Disability Access

Report:

School Classrooms, Staff &

No. 369 Jacks Corner Road

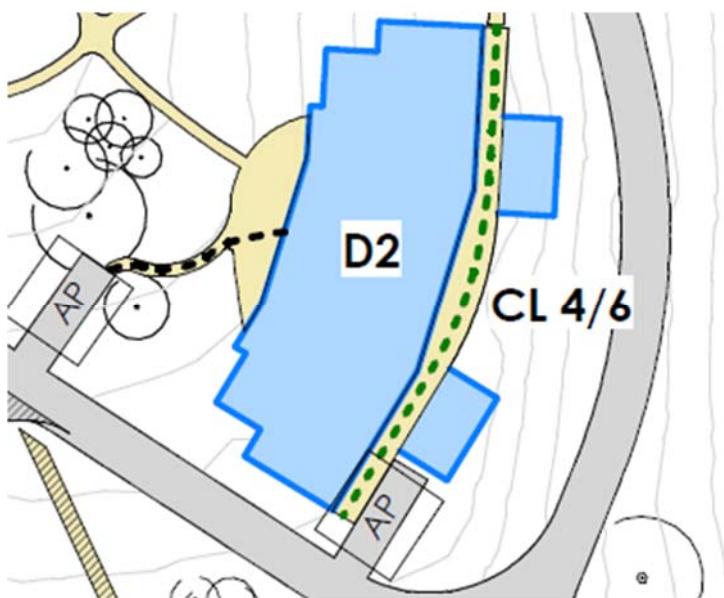
The green line is an accessible path from the Designated Accessible Parking Bay to Classrooms 4-6:

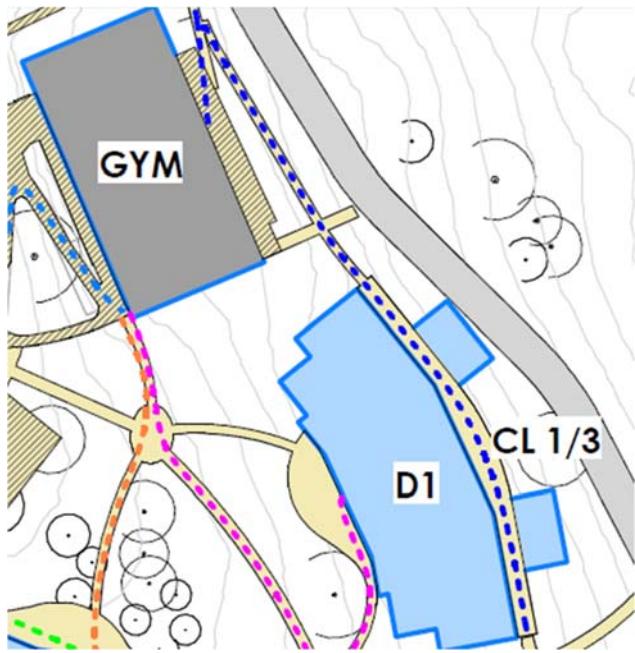
The blue line is an accessible path provided from the Designated Accessible Parking Bay to Classrooms 1-3 (and the gym lower level):

Accessibility Plan (coloured lines indicate an Accessible path):

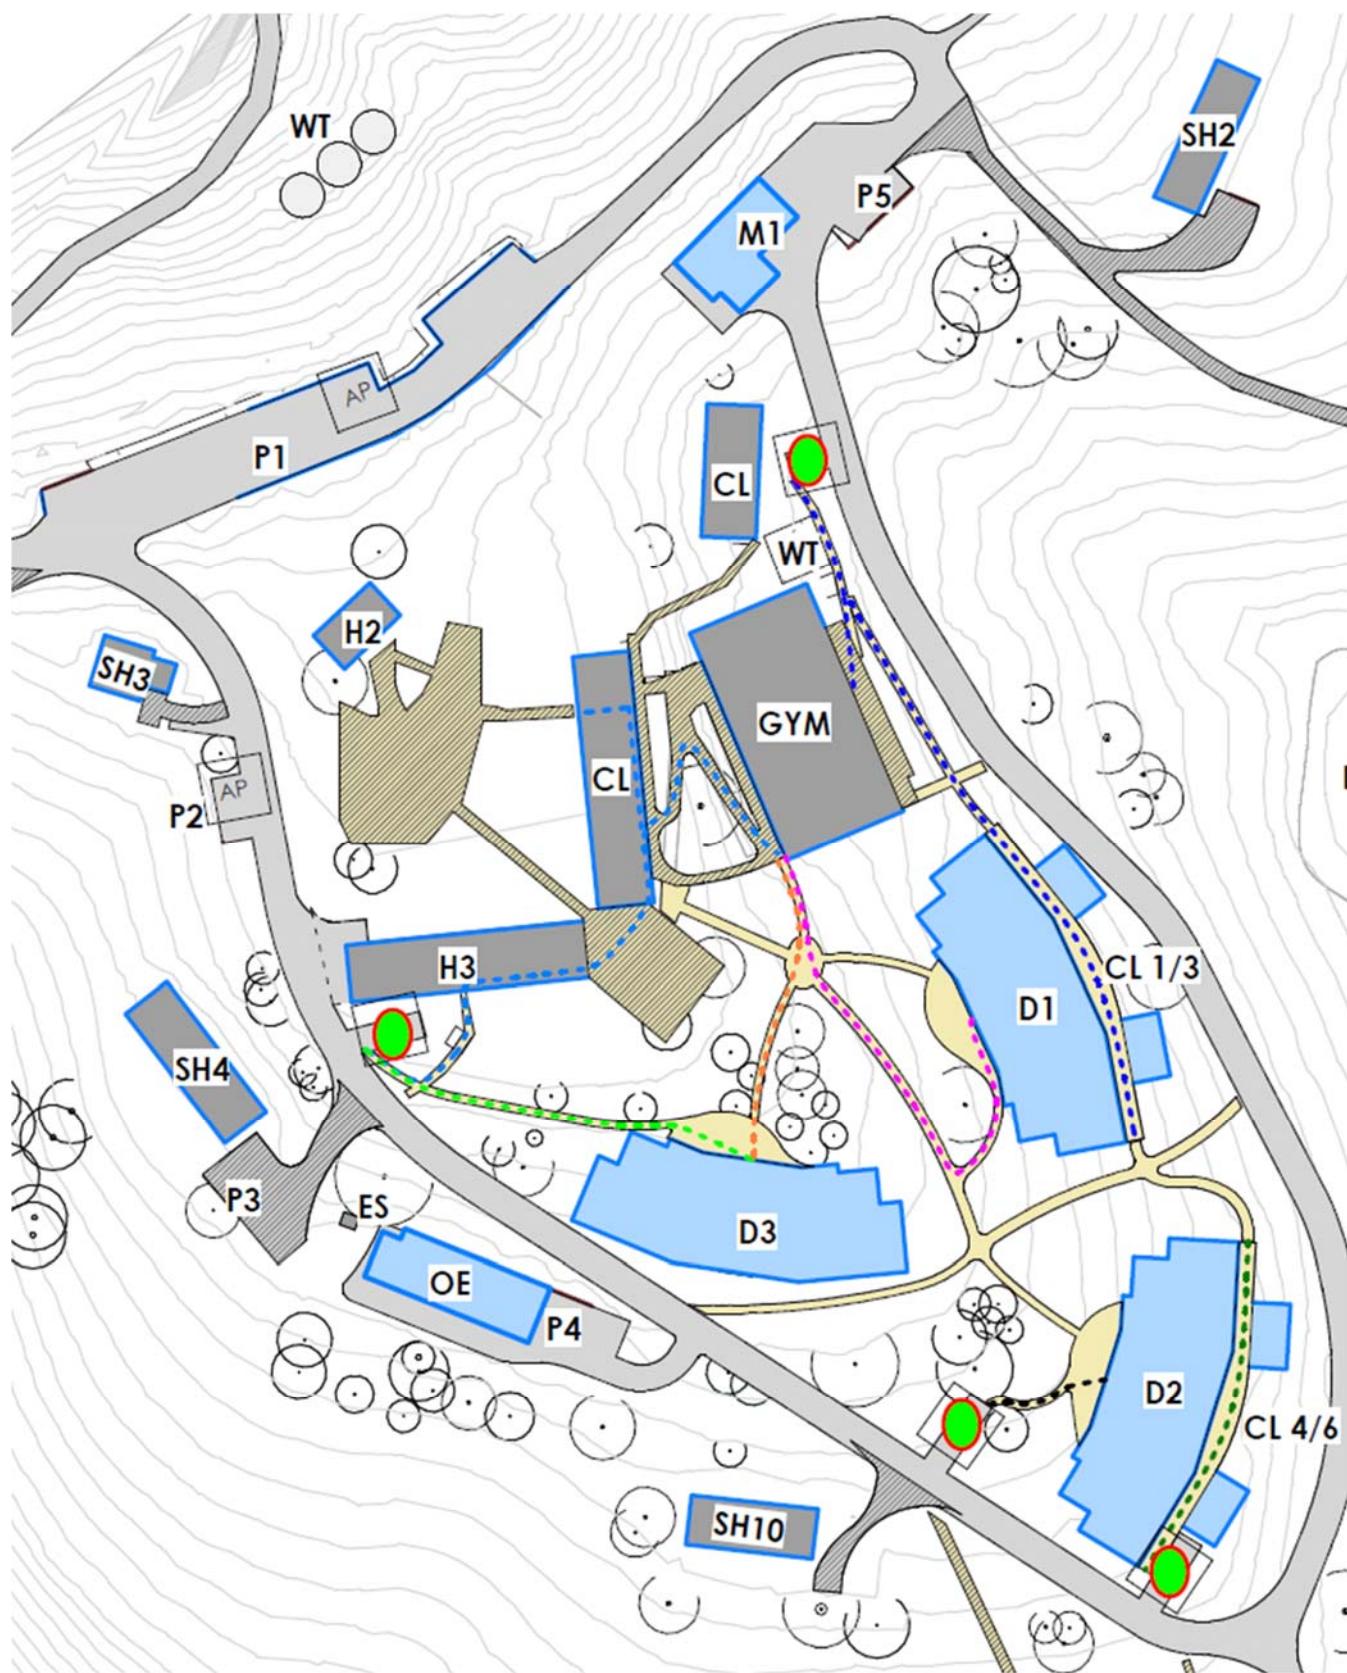
The proposed performance solution is to provide a Continuous Accessible Path of Travel (CAPT) to and between buildings D1, D2, D3 and the gym.

The following are the key factors that support the case that the relevant Performance Requirements of the NCC will be met (see a map of the proposed accessibility plan in Diagram 1 below):
